Re: Questions for zoning redesign

**RE:** Comments on the Planning Department's revised provisions of the Residential

APPENDIX A: Questions and Concerns on Zoning Ordinance Version 3 by Councilor Pam Wright #88-20						
No.	Section	Proposed Zoning Code v080720 or PD comment	Question/Concern	Recommendation/ Comment			
1	Overall	Proposed new zoning code	Understanding implications for existing Housing Stock	Build out analysis			
2	Overall	Proposed new zoning code	Understanding property tax and infrastructure costs for Newton residents	Financial, traffic and infrastructure impacts			
3	Overall	Proposed new zoning code	Understanding implications for existing Housing Stock	Tear down analysis			
4		According to the mayor's email to me "The City Council is in charge of writing the zoning and, when asked, the Planning Department provides the Council with their professional opinion."	In my opinion the Zoning & Planning Committee is not "in charge" of the writing of a new zoning code. Please explain why we as a Committee are not following the process delineated to me by the Mayor.	Define and follow process

# 3.2.7. DuplexTwo-Unit Residence

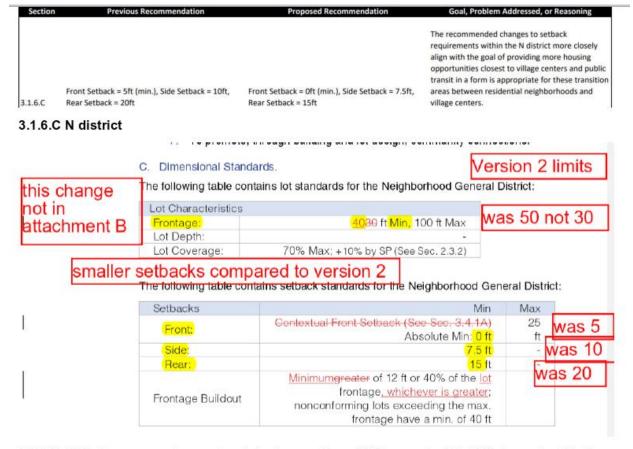
APPENDIX A: Questions and Concerns on	Zoning Ordinance Version 3 by Councilor Pam Wright	#88-20
No.	Section	Proposed Zoning Code v080720 or PD comment	Question/Concern	Recommendation/ Comment
40	3.2.7.A	2 unit (duplex) definition	Interesting - 2 family is either duplex (on top of each other) or Philadelphia style – not townhouse style. Must have 2 Residential Units, one on the first floor and one on the second floor. Alternatively, may have 2 Residential Units with the first unit comprised of the first floor and a portion of the second floor, and the second unit comprised of the remainder of the second floor.	
41	3.2.7.B	Duplex footprint	Why 1800 sf footprint? Missing middle recommends 2 and 3 unit builds same footprint as single family (1400 sf)	Discussion
42	3.2.7.C	Fenestration	Review fenestration. Are the numbers appropriate?	Explanation
43	3.2.8.B	Triple decker footprint	Per the missing middle, triple decker footprint should be the same size as a house – 1400 sf.	Discussion
